1 **Alexandria Waterfront Commission**
2 **Waterfront Flood Mitigation Committee**

3
4 **Waterfront Flood Mitigation Position Statement**
5 ***Draft for Waterfront Commission Consideration***
6 ***April 14, 2022***
7
8

59 **Figure 1: Proposed Phase 1 Waterfront Flood Mitigation Improvements**

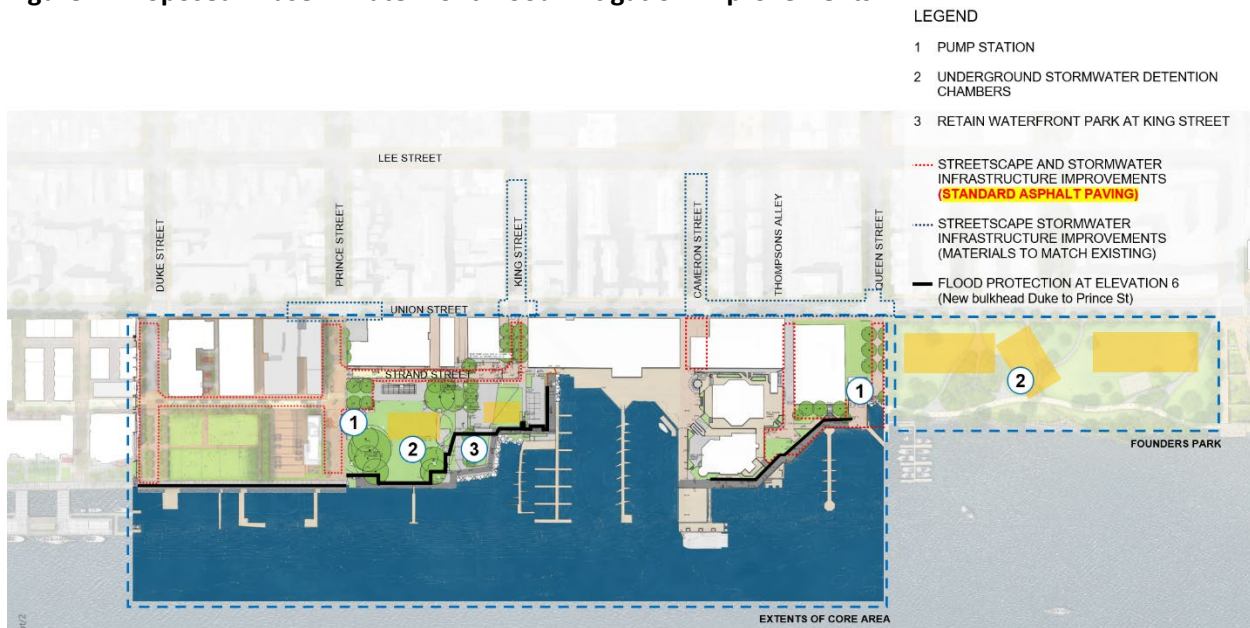
50 The Waterfront Flood Mitigation Committee recommends to the Waterfront Commission that City staff
51 continue to pursue the Phase 1 improvement scenario as presented by City of Alexandria Department of
52 Project Implementation staff to the Waterfront Flood Mitigation Committee (Figure 1). The committee
53 understands that this design and the specific anticipated features—including flood protection, pump
54 stations, underground stormwater detention chambers, and streetscape and stormwater infrastructure
55 improvements—will be subject to further refinement by the City’s Progressive Design Build contractor,
56 based on community input, innovative design solutions and new information as project development
57 continues.

69 Based on information presented to the committee by City staff, this scenario should be evaluated by the
70 Progressive Design Build contractor and cost benefit analysis conducted against other possible
71 alternatives for construction. Its proposed features include pump stations in Waterfront Park and the
72 Queen Street right of way, south of Founders Park, underground stormwater detention chambers under
73 Waterfront Park and Founders Park, and retention of the recent improvements in northern Waterfront
74 Park at the foot of King Street.

76 This scenario also includes streetscape and stormwater infrastructure improvements but manages costs
77 by using standard asphalt paving within the public Right of Way as indicated in Figure 1. The Waterfront
78 Flood Mitigation Committee recommends evaluating the use of cost-effective paving material, in lieu of

79 the previously adopted common elements, which could provide cost savings that may be invested in
80 other elements of the plan.

83 The Phase 1 scenario as recommended by staff incorporates a traditional bulkhead between Duke and
84 Prince streets as depicted in Figure 1. Staff also presented a potential alternative for Commission
85 consideration (and further evaluation by the Progressive Design Build Team) which partially naturalizes
86 the riverscape at Point Lumley as depicted in Figure 2. This approach minimizes the cost of capital
87 improvements and associated regulatory mitigation costs due to impacts in the river, associated with
88 constructing a traditional bulkhead in this area. This approach could also provide the intended level of
89 flood protection at a reduced capital cost.

- 155
- 156 • For the reasons described above, both a traditional and hybrid approach to the bulkhead and
157 promenade (as shown in Figure 1) from Duke to Prince streets at Point Lumley should be
158 considered.

Figure 2: Hybrid Shoreline at Point Lumley

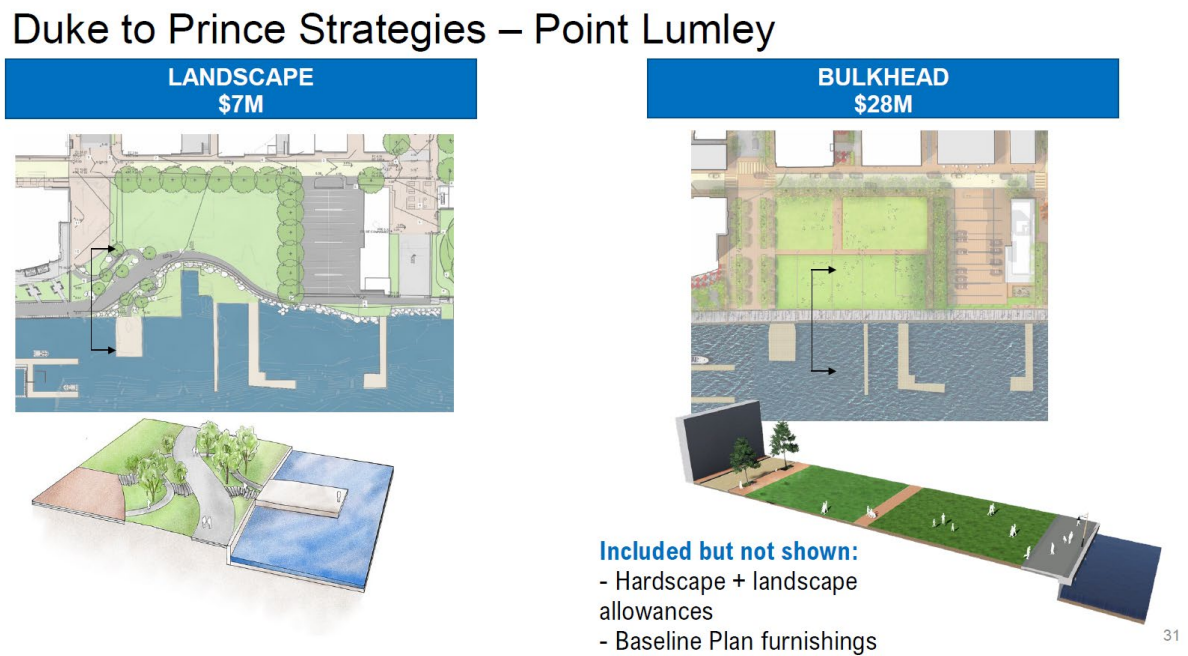
91 The Waterfront Flood Mitigation Committee believes that a hybrid shoreline approach could provide an
92 acceptable alternative to the bulkhead promenade proposed for this location in the 2014 Baseline
93 Schematic Landscape and Flood Mitigation Design and supports the key 2012 Waterfront Small Area
94 Plan objective of providing a continuous pathway along the waterfront.
95

101 The Waterfront Flood Mitigation Committee supports continued consideration of the hybrid shoreline
102 approach. The avoided cost of constructing a bulkhead promenade at this location may be reinvested in
103 other elements of the Waterfront Implementation Project. Therefore, the Waterfront Flood Mitigation
104 Committee recommends that City staff consider a hybrid approach to the shoreline at this location for
105 further development by the Progressive Design Build team. Consideration of both the hybrid and
106 traditional options should continue, in the event funding materializes to construct a traditional bulkhead
107 as planned.

108
109 The Waterfront Flood Mitigation Committee recommends that the Waterfront Commission request City
110 staff to clarify how savings from constructing a hybrid shoreline will be reinvested, to make certain that
111 amenities provided during Phase 1 in lieu of a traditional bulkhead are consistent with waterfront plans
112 and priorities, including the recommendations for prioritized investments outlined below.

113
114 If a hybrid bulkhead approach is implemented, the City should consider the visual continuity of
115 naturalized shorelines by coordinating the look and feel of hybrid and natural shorelines in the core area
116 and other sections of the waterfront, such as the features incorporated into the recently-renovated
117 Windmill Hill Park shoreline.
